City of Portland, Maine - Building or Use Permit Application

Permit No: 01-0644	Issue Date: JUN 12 2001	CBL: 388 H020001
-----------------------	----------------------------	---------------------

Proposed Project Description: erect a 20' x 20' unattached deck	FIRE DEPT: <input type="checkbox"/> Approved <input type="checkbox"/> Denied	INSPECTION: Use Group: R-3 Type: B3 BOCA/IBC/1997 PERMIT ISSUED PEDESTRIAN ACTIVITIES DISTRICT (P.A.D.)
Signature:	Signature:	Signature:
Action: <input type="checkbox"/> Approved <input type="checkbox"/> Approved w/Conditions <input type="checkbox"/> Denied	Signature:	Date:

BUILDING PERMIT REPORT

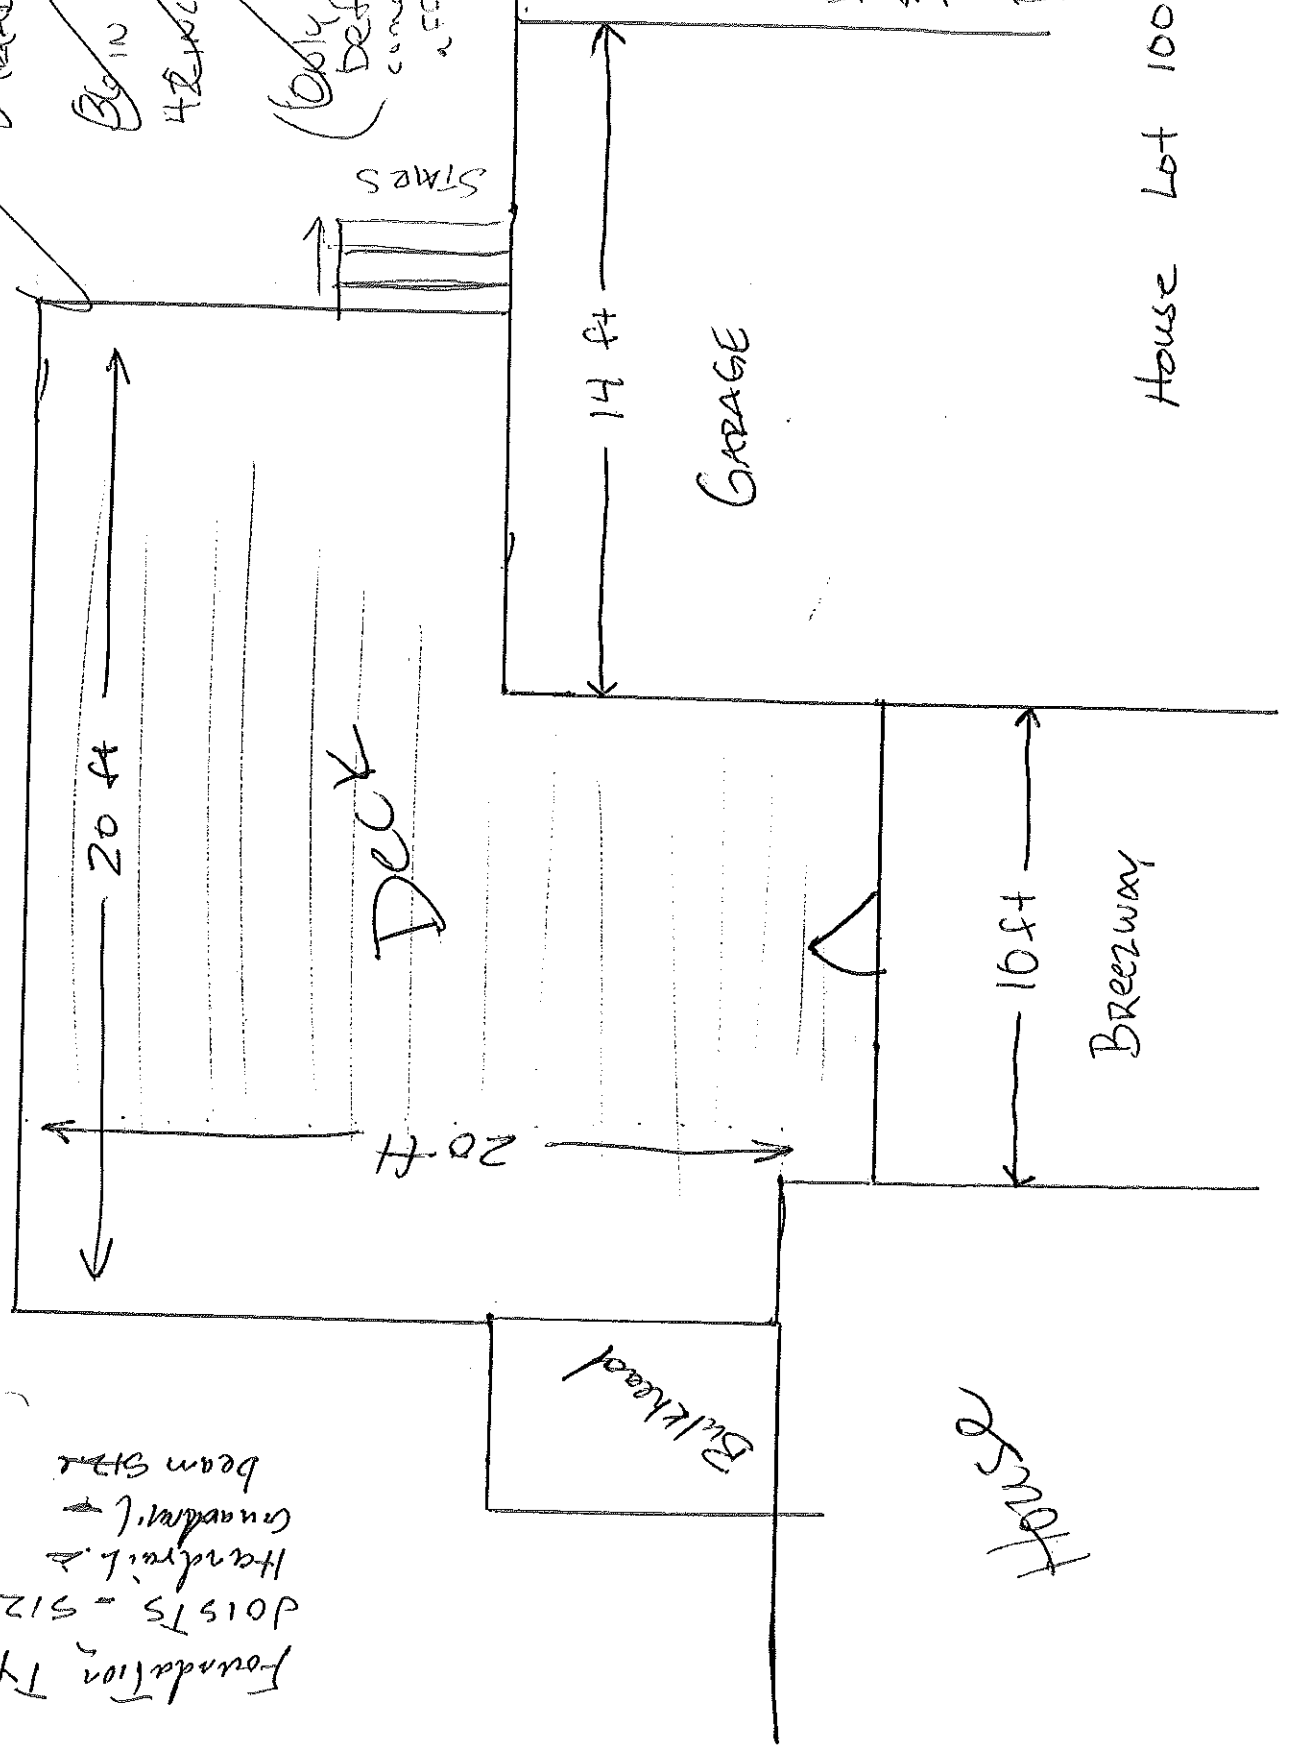
Over 25 ft
From Rear Setback

Max Riser 7 3/4

Tread Depth 10"

36 in off grade
42 inch HAND RAIL
GUARD

(Only if approval
before 36 in.
comes back into
effect. zoning)

REAR: 25' req - 25' shown

SIDES: 12' req - 12' implied
